Commonwealth Edison Company

September 9, 1966

Amendment No. 2 to Application for Construction
Permit and Operating License - AEC Dkt. 50-258

In response to your letter of August 24, 1966, requesting additional information to support the Application for Construction permit for Units 1 and 2 at Quad-Cities Station near Cordova, Illinois, Amendment No. 2 to the Plant Design Analysis is submitted herewith.

FIGURE C-2-1
RESPONSE ACCELERATION
SPECTRA

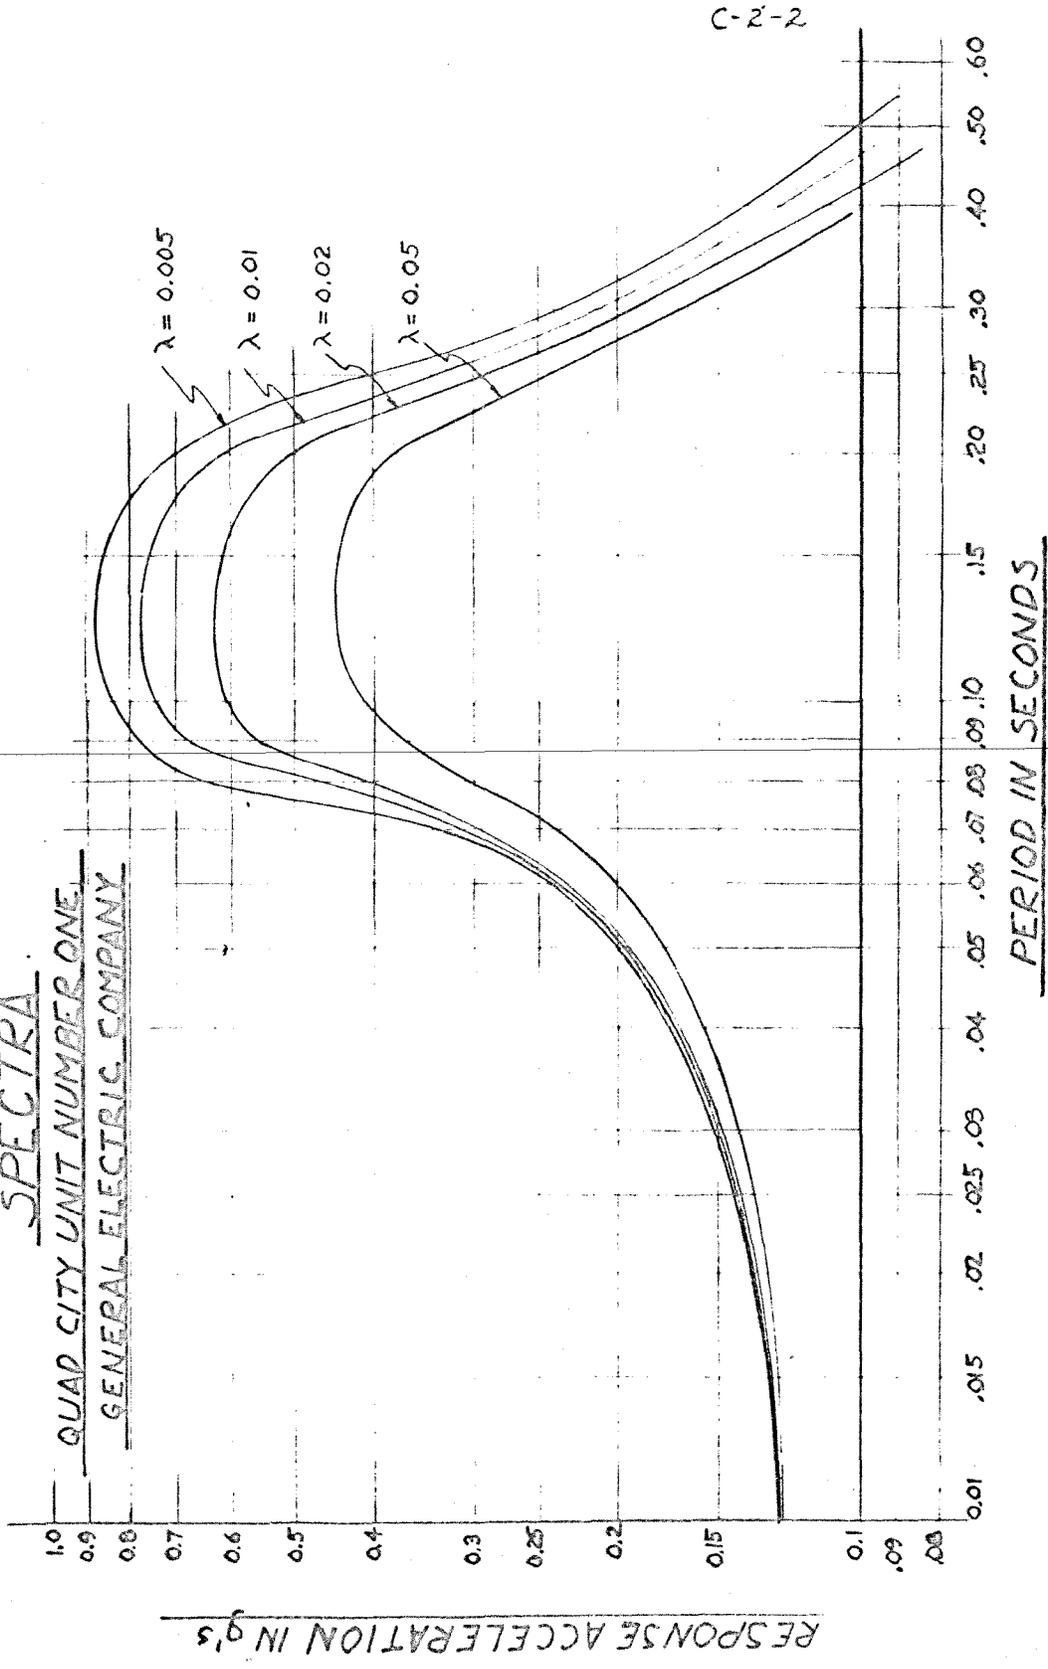
2. What is the source and applicability of the response acceleration spectrum plot on Plate V of Appendix F? Please provide a more accurate plot on log paper to include the short period range.

The response acceleration spectrum plot on Plate V of Appendix F was developed through studies made of local and area geology, seismology, and seismic history by John A. Blume and Associates, Engineers. Dr. Ross Heinrich was Consulting Seismologist. Because most of the critical components and structures are modeled and subjected to an excursion through ground motion, it is desirable to adopt an actual earthquake record which produces a response in agreement with that postulated on the basis of the seismic investigations. In this case, the 1957 San Francisco Golden Gate Park S80E was chosen.

The purpose of the spectra shown is to provide earthquake response in a dynamic analysis. These are averaged single-mass spectra and are usually employed in a model analysis. These are not generally used in the analysis of important critical components, since computer programs are utilized which follow the actual earthquakes, rather than their response curves, and it is not necessary to combine modes in some approximate manner to arrive at final shears, moments and displacements.

The response acceleration spectra are presented on a log-log plot as shown on the attached figure. As explained above, these curves are not generally used in the analysis of important critical components, since computer programs are utilized which follow the actual earthquakes.
